PRODUKTINFORMATION 0061- GB
PRODUCT INFORMATION

Von / From:	Susanne Suttrop ■ GR-B ■ Tel: 519 ■ s.suttrop@allweiler.de	
Kopie an / Copy to::	Sales Infos Weltweit	
Datum / Date:	03. August 2010	Seite/Page 1 von/of 4
Produkt / Baureihe Pump Type:	SPF series

Anlaß / Occasion:	Adapter flanges for the conversion SPF to ALLFUEL
-------------------	--

Maßnahmen/ Measures:	ALLFUEL replacing SPF / SPZ / BAS / ZAS / ZASV
----------------------	--

Exchange / Replacement option

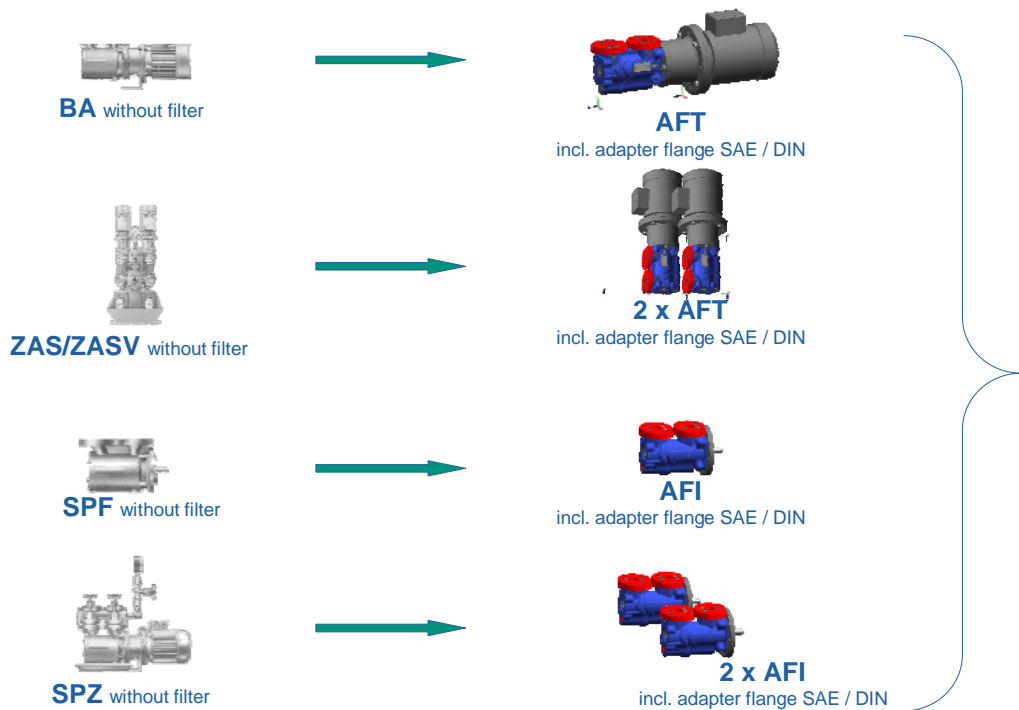
The new and superior ALLFUEL series has been available for these applications since May 1, 2009 and can be integrated in existing installations by using adapter flanges (overview p. 3). In case of horizontal mounted SPF/BA pumps without filter the AFI- and AFT-pumps can be directly connected via the adapter flanges, any other changes are not necessary.

The counter flanges in the existing systems have to correspond to the welding-neck flanges, delivered by ALLWEILER (acc. EN1092-1 PN40 Typ11 Form B)
